Section 92A Response – APP-2006012018.02

To: Horizons Regional Council

From: Sukhi Singh, Technical Director Planning

Copy: Mike Ryan, CEO, Winstone Pulp International Limited

Figure 2. Concept cross-section for the proposed constructed wetland system (not to scale).

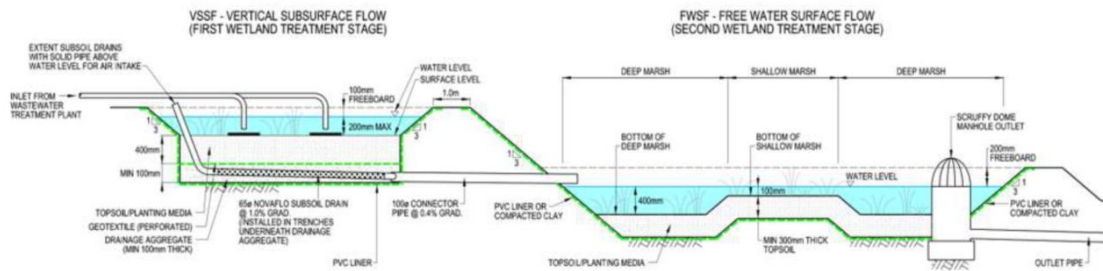
a. At pages 8-10 of the Planning Report, the wetland concept design and associated construction works are described, including about 22,441 m³ of cut and fill over 17,146 m². The lodged material indicates that aspects of the wetland construction package remain subject to further design. Please confirm which elements of the wetland footprint, staging and cut / fill methodology are finalised, and which remain to be confirmed.

- The extent of the proposed earthworks is limited to the construction of the proposed wetland (as requested by Ngāti Rangī in their submission). The wetland construction includes two stages, as explained below.
- Stage 1: Earthworks construction: Figure 2 in Water Quality Assessment Memo details the concept cross section for the proposed wetland system (copied below). Technical Memo 4 (Wetland Construction – Erosion and Sediment Control Plan (“ESPN”) outlines the full extent of the earthworks, finishing at the wetland base, delineated by the installation of the impermeable HDPE liner (being the green line shown in the illustration below).

- Stage 2: Planting plan: the detailed design for this stage of the wetland has not being completed at this bulk earthworks stage. Stage 2 works includes landscape design work that sits above the HDPE liner (i.e. above the green line shown in the illustration above). Being a shallow wetland, no fill material is required to complete the wetland construction. The figure above illustrates that a layer of drainage aggregate, geotextile and topsoil/ planting media will be placed above the HDPE liner. The applicant is supportive of a condition of resource consent requiring the completed Wetland Planting Plan be provided to council.

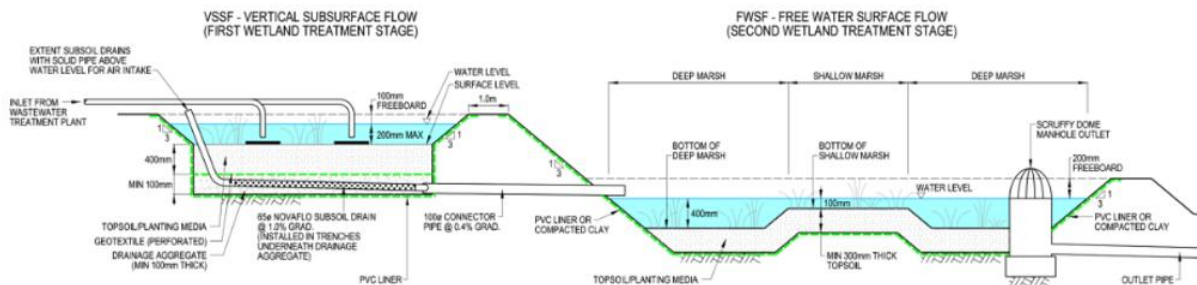
a. At pages 8-9 of the Planning Report, the wetland is described as a vertical subsurface flow system with vertical percolation and infiltration media, while pages 4-5 of the RAP refer to an impermeable layer to prevent downward infiltration into the former pond area. Is the proposed wetland lined, partly lined, or unlined? The plan indicates that the liner may be PVC or clay lined. Please confirm if the wetland is proposed to be lined or not and if so provide the proposed liner specification, including liner type, permeability, construction standard, and how the liner will prevent or minimise seepage from the wetland to land or groundwater.

- The proposed wetland is designed to be lined to prevent seepage to underlying soils and groundwater and to retain water within the constructed wetland.
- The mentioned "vertical percolation and infiltration media" are associated with the designed layers within the wetland (i.e. above the HDPE liner).
- Consistent with the RAP and the wetland concept design, the wetland will incorporate an engineered HDPE (high-density polyethylene geomembrane) liner system across the base and sides of the treatment cells as shown below (Figure 2 of the Water Quality Assessment Memo).

- The HDPE liner acts as impermeable barrier to prevent water seepage. It is intended to prevent downward infiltration into the former pond area and underlying soils, thereby ensuring hydraulic control and protection of groundwater.

- Thickness: typically 1.5–2.0 mm
- Permeability: effectively impermeable ($\leq 10^{-13}$ m/s equivalent)
- Installed in accordance with recognised standards (e.g. welding QA/QC, seam testing – GRI-GM19, ASTM D6392, liner integrity certification, etc)
- The technical specifications of the HDPE liner will be provided at the detailed design stage and will form part of the information to be incorporated in the Wetland Landscape Plan (to be included as a condition of resource consent).
- The objective of the design intent of the HDPE liner is to:
 - Provide a continuous low-permeability barrier beneath and around the wetland cells
 - Prevent seepage and infiltration to land and groundwater
 - Maintain hydraulic containment within the wetland treatment system
 - Ensure flows are directed through the intended treatment pathway prior to discharge
